Memorandum

Project Name: Hamlet of Pangnirtung Project #: FRE-00232735-A0 /File No:

Subject: Pangnirtung Water Reservoir – Berm Repairs

Figure A: Photo of the erosion caused by surface water near the northeast corner of the water reservoir.

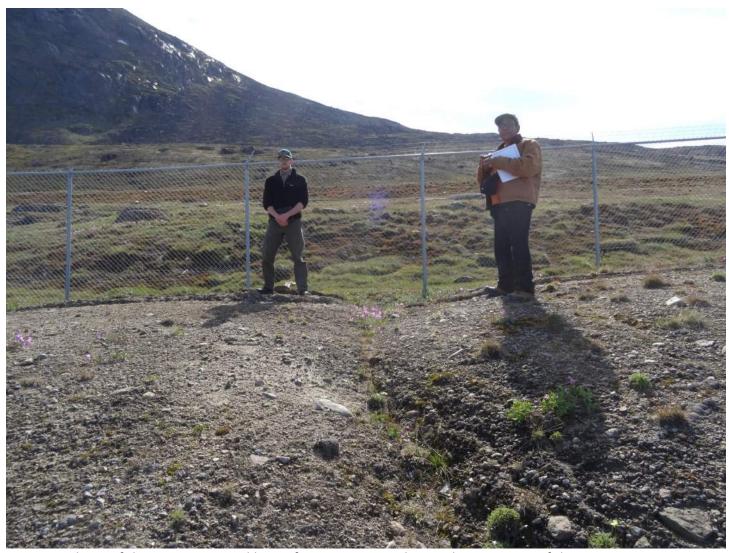
- 1. Water is being withdrawn from the Duval River as approved in the Water License by a diesel pump located near the riverbed.
- 2. In 2015, the Hamlet of Pangnirtung withdrew approximately a total of 51,217m³ of water and is withdrawing water at approximately the same rate in 2016.
- 3. The berm wall around the reservoir has a depression near the northeast corner. This was likely caused from upstream surface water run-off. The depression is likely allowing surface water from the surrounding environment to flow into the reservoir during heavy rainfall events only. This should be addressed to maintain the designed integrity of the structure. See *Figure A*.
